**NUMBER:** 08-049-17

Central Vision Processing Module (CVPM) Enhancements for Surround View Camera System

2017 (RU) Chrysler Pacifica

Fig. 1  
360 Surround View Camera

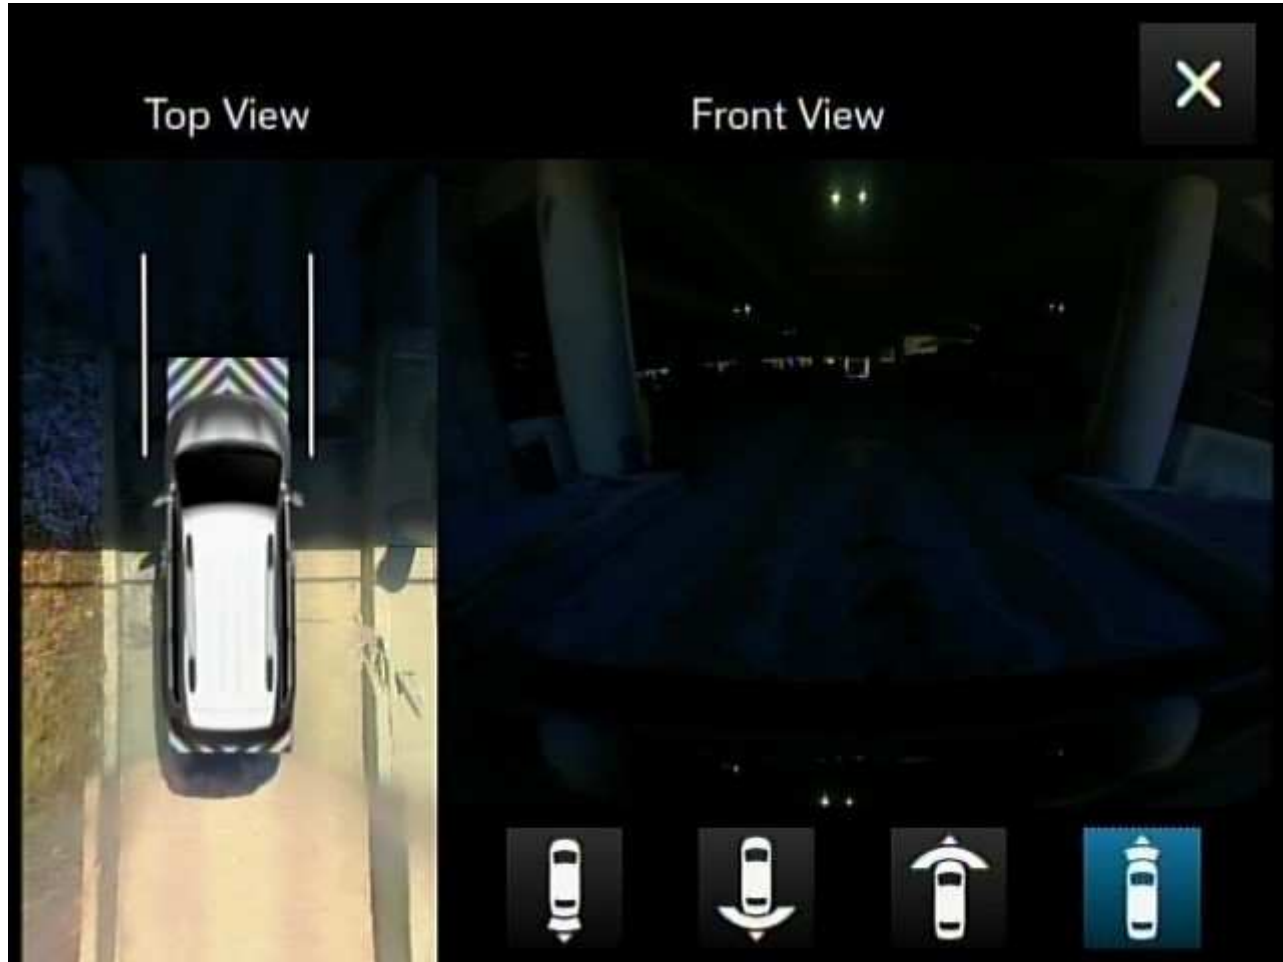
Customers may experience that in variable light conditions (i.e. backing into a garage on a sunny day), image harmonization between the four views can lead to part of the image being blacked out (Fig. 1) .

1. Reprogram the CVPM with the latest available software. Detailed instructions for flashing control modules using the wiTECH Diagnostic Application are available by selecting the application's "HELP" tab.
